Project:	AEG6585_RH16_HaywardsHeath		
Author:	[REDACTED]		
Revision: -	Addendum	Date:	18 December 2024

Introduction

Aegaea have previously produced a Flood Risk Assessment (FRA) for the proposed development at 17 Blackthorns, Haywards Heath, Mid Sussex, West Sussex, RH16 2AX (AEG6585_RH16_HaywardsHeath_01, 26/11/2024).

Figure 3: Cross section through EA 1m LiDAR and EA Surface Water Flood Risk Mapping – 1 in 30 year Flood Depths (Base map from Google Hybrid ©. Contains public sector information licensed under the Open Government Licence v3.0)

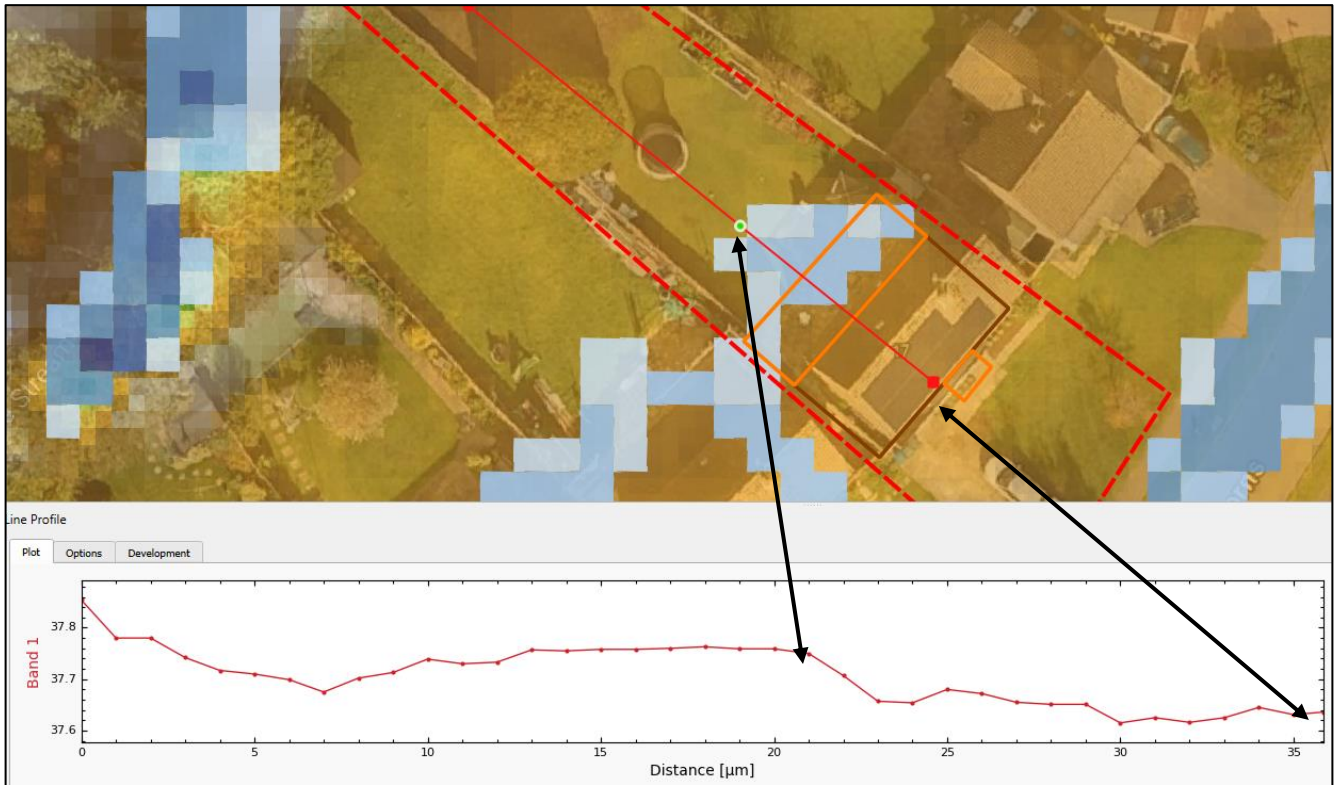
This area of ponding at the rear of the footprint is likely derived in the RoFSW model from the EA's LiDAR data, which has a potential vertical discrepancy of +/- 15cm in some areas. A section through the EA's LiDAR at the site is presented in Figure 3 below. It can be seen from Figure 3 that the LiDAR suggests that there is a circa 200mm drop in ground levels from the grassed area of the garden down to the dwelling.

However, this is clearly not the case as seen from the submitted photo sheet within the architects plans within the FRA. The architect plan photos 1 to 3 (which can be found in Appendix A of the FRA and are provided in Figure 4 below for ease of reference) shows the patio area to the rear of the property to be flat. Therefore, there is likely a post-processing error within the EA's LiDAR, and thus the RoFSW model represents an inaccurate scenario, not reflecting the actual topography of the site.

Therefore, the area to the rear of the property at a 'High Risk'/ affected in the modelled 1 in 30 year event within the RoFSW dataset appears to be erroneous.
